**Town of Kittery
Planning Board Meeting
February 27, 2020**

ITEM 2 – 76 Dennett Road – Sidewalk/Street/Landscape Design Discussion

Action: Approve or deny street, sidewalk and landscape designs. Owners William J. Cullen and Sail Away, LLC and applicant William Wharff were granted preliminary plan approval on September 26, 2019. That approval was granted with conditions, one of which was to present sidewalk designs per the requirements of Title 16. Applicant will also present street design and landscape design. Agent is Shawn Tobey, P.E. Hoyle, Tanner & Associates, Inc

REAR LANDSCAPING PLAN
C20
 PROJECT NO. 569200
 SHEET 20 OF 28

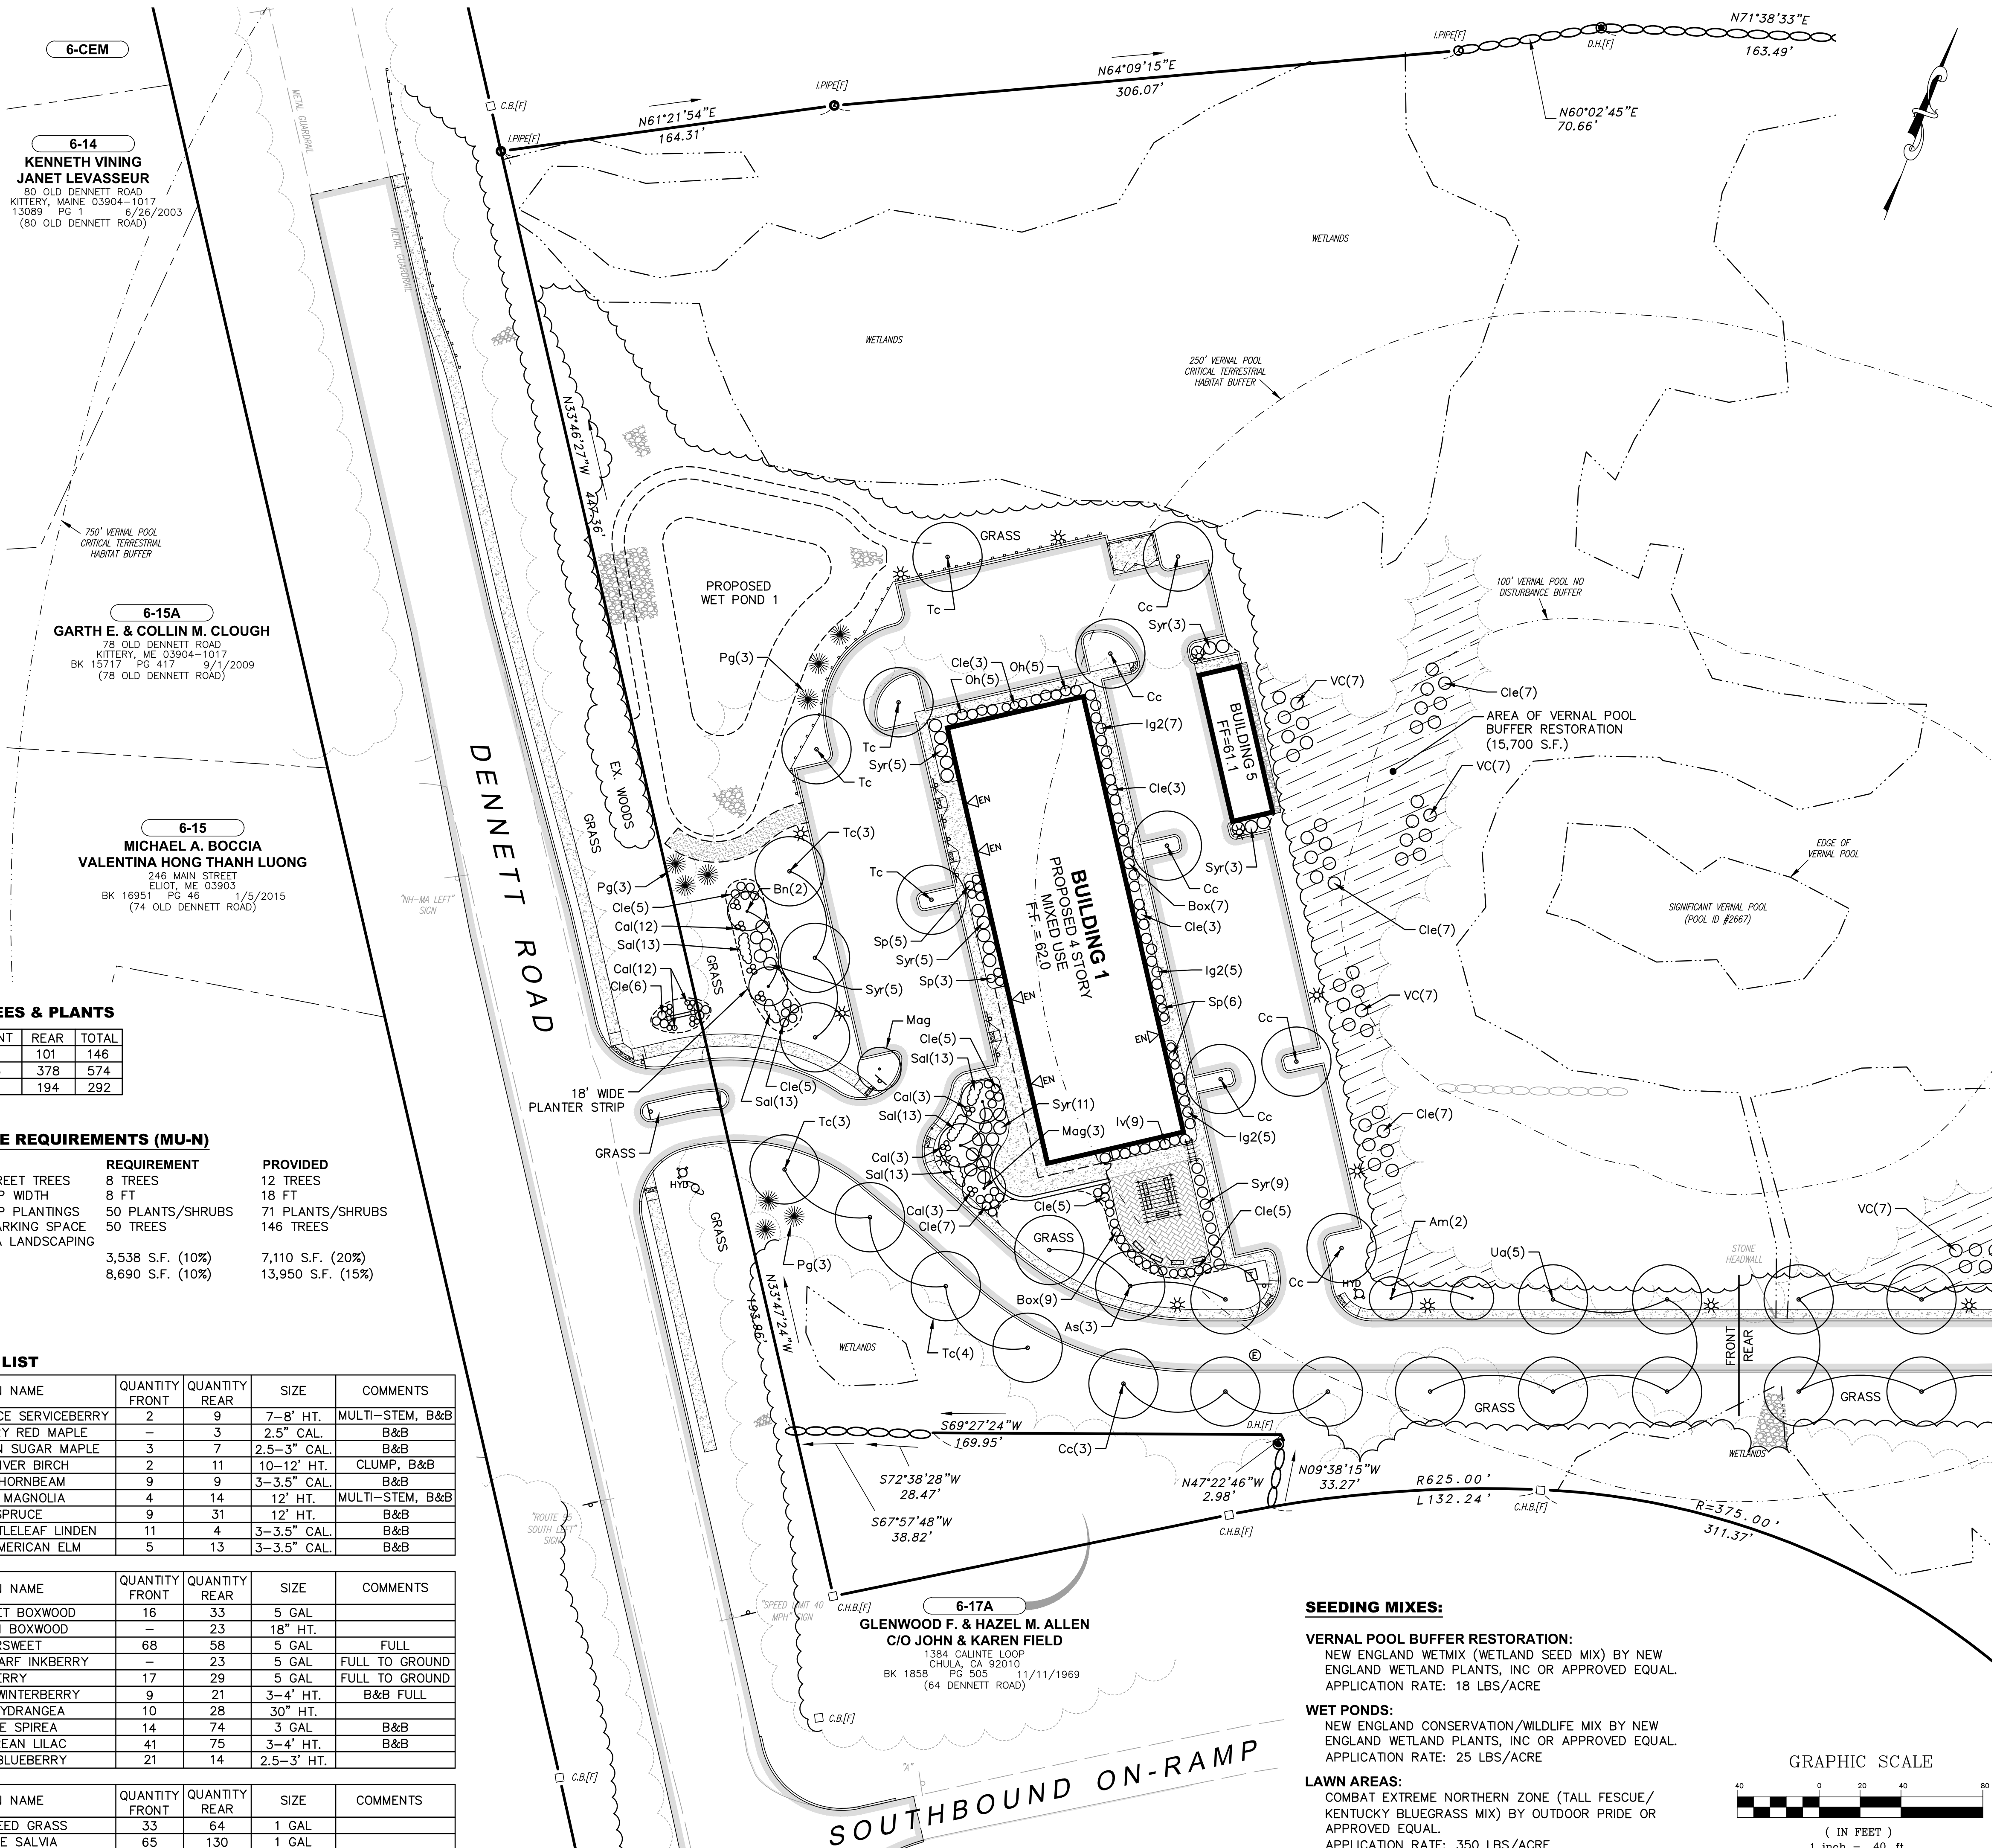
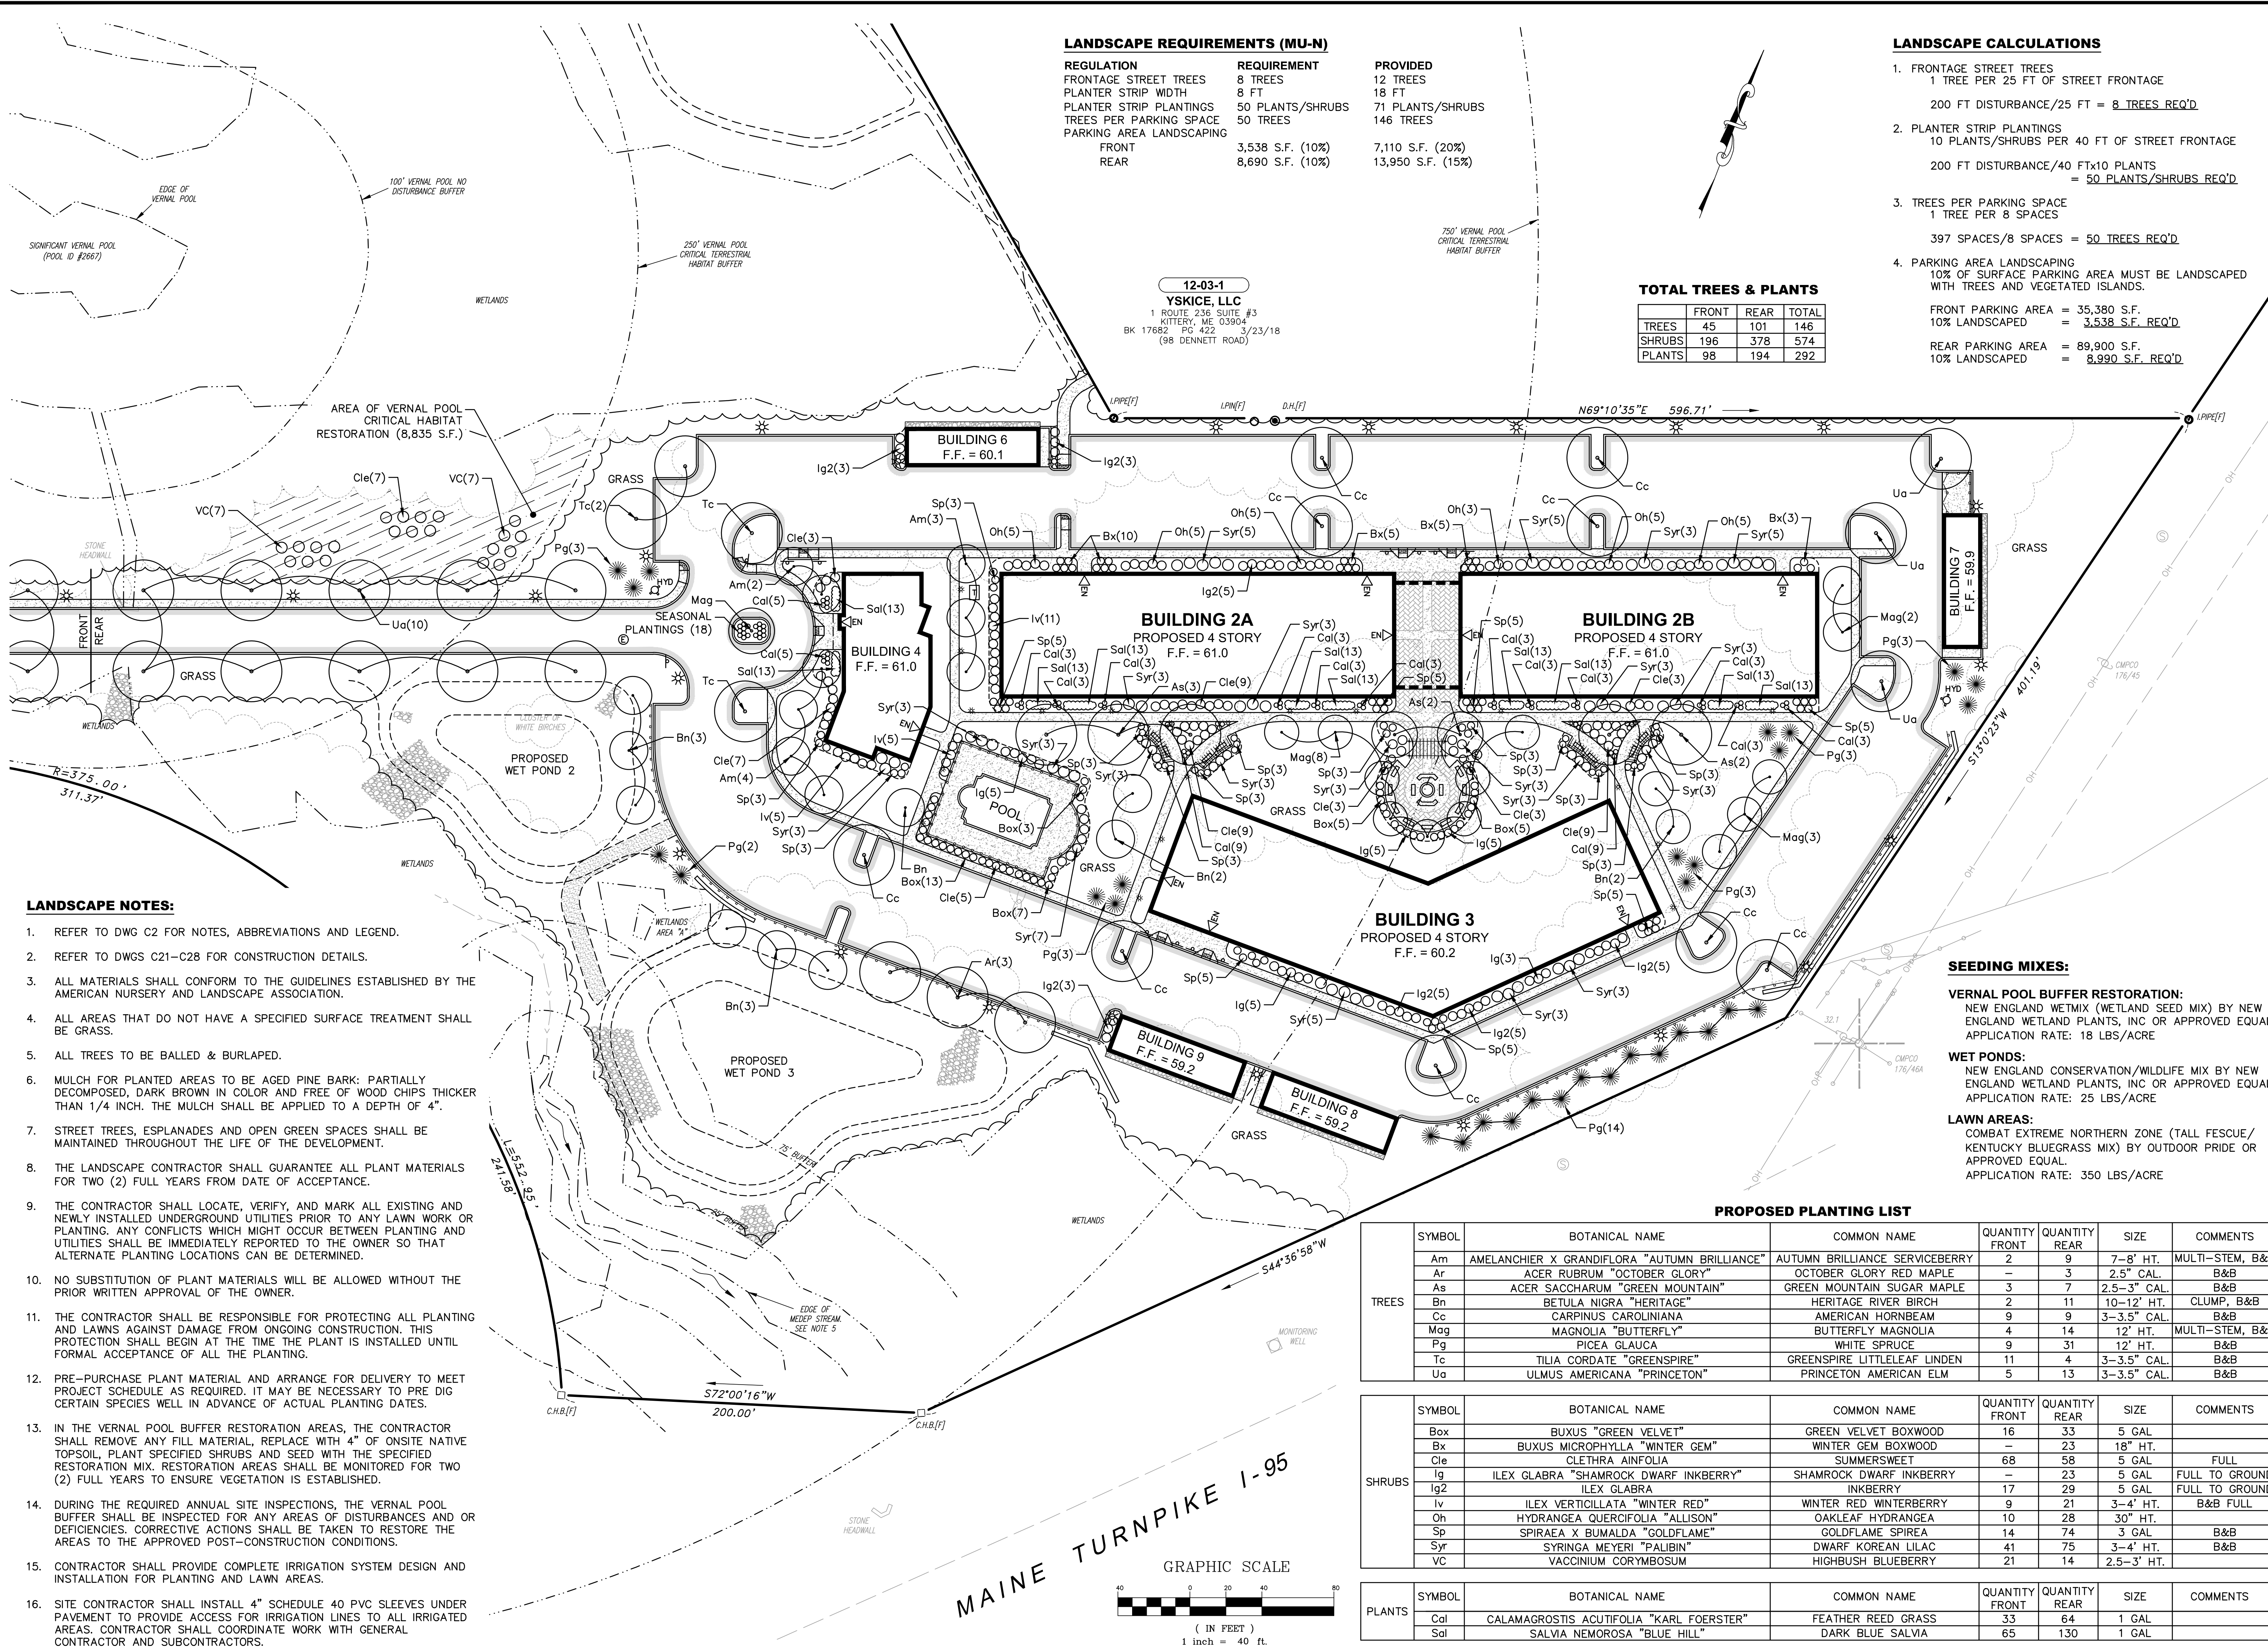
Jeffrey Hyland, of Ironwood Design, at the request of CMA, has reviewed the landscape plans. The Applicant has responded to the comments to Jeff's satisfaction (letter included in packet for February 13th meeting) with revised landscaping plans (see Sheet C19 and C20).

- All third-party landscape review comments from Ironwood were thoroughly addressed.
- The proposed onsite booster pump and building were removed from the design plans. Based on the Hydraulic System Analysis prepared by Wright-Pierce dated November 25, 2019 and coordination with the Kittery Water District, each building shall have individual booster pumps located within the building for both domestic and fire services to provide adequate water pressure to all floors. The proposed onsite water line will be stubbed at the rear property line with the intent of a future loop connection to the existing water located within the Route 236 right of way. If this connection were to occur and the Kittery Water district assumed ownership of the water line, it would not be practical to have a privately owned booster pump connected to the line.
